24 January 2020

## Product Change Notice

Part Series Affected: 89 Series (Prefix 805,810,825)

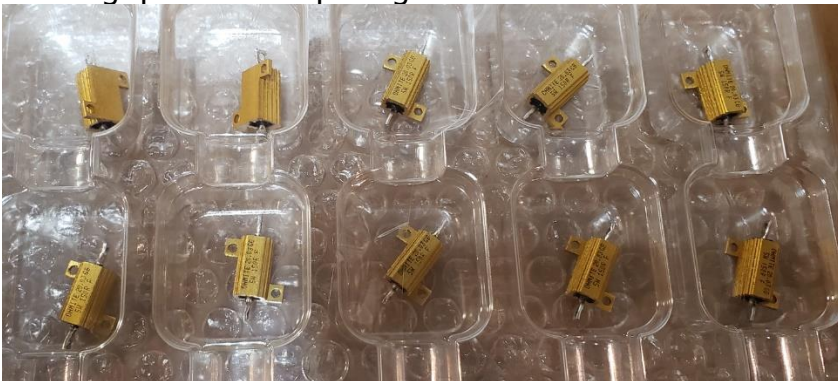
Starting January 23, 2020 the Ohmite 805, 810, and 825 Series resistors will be supplied in 10 piece drop trays with lids to better protect them from damage during transit, and in the interest of packing efficiency and cost. The standard pack quantity will be unchanged from 10 pieces, no changes to ordering quantities or pricing.
